Original PA Reference: 25/00806/FLL Original Eplanning Reference: 100714653-001

- 1.1 Ryden is appointed on behalf of Ms J. Maude in relation to an application for full planning permission submitted to Perth & Kinross Council under reference 25/00806/FLL (Document 2).

- 1.2 The application is for "Alterations and extension to dwellinghouse, erection of a garage and plant building, installation of a retaining wall, alterations and extension to access road, formation of patio and associated works" at Boat of Murthly, Dunkeld, PH8 0JA ("the site") which is a Category B Listed Building. A sibling application for Listed Building Consent (25/00807/LBC) was also submitted and is the subject of a separate appeal to the Scottish Government's Division of Planning & Appeals (DPEA).

Fig 3. Existing roof plan (plan 08) and proposed roof plan (plan 38).

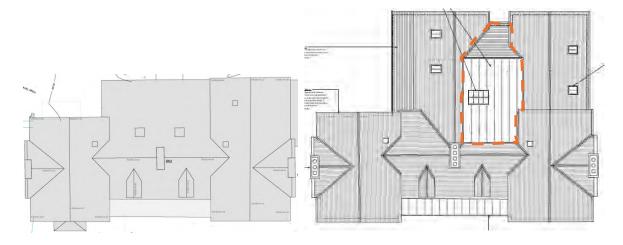
arrangement offered by the original form, existing catslide roof and modern c1970s two-storey extension (see Fig. 3).

As informed by HES Managing Change in the Historic Environment on 'Roofs', para 4.3 notes that "alterations to subsidiary elevations [...] are likely to have less visual impact on the character of a building." In the interests of clarity, and as argued by the agents in their supporting information, the rear elevation is not considered a subsidiary elevation given that this elevation features significant architectural character which, if unsympathetically altered or extended, would result in detrimental change and character erosion.

View on approach, as proposed

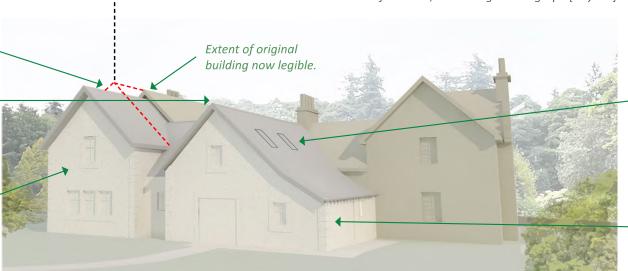
Proposed east wing extension ridge to be lower than existing/ original ridge. Red dashed line indicates existing extension to be removed.

The adjacent images, from the same viewpoint, illustrates the existing condition and the refinement to the proposals. Figure 4 responds to the HES comments and some of the detailed issued raised, including lowering the height of the central gable and new rooflights on the lean-to roof.
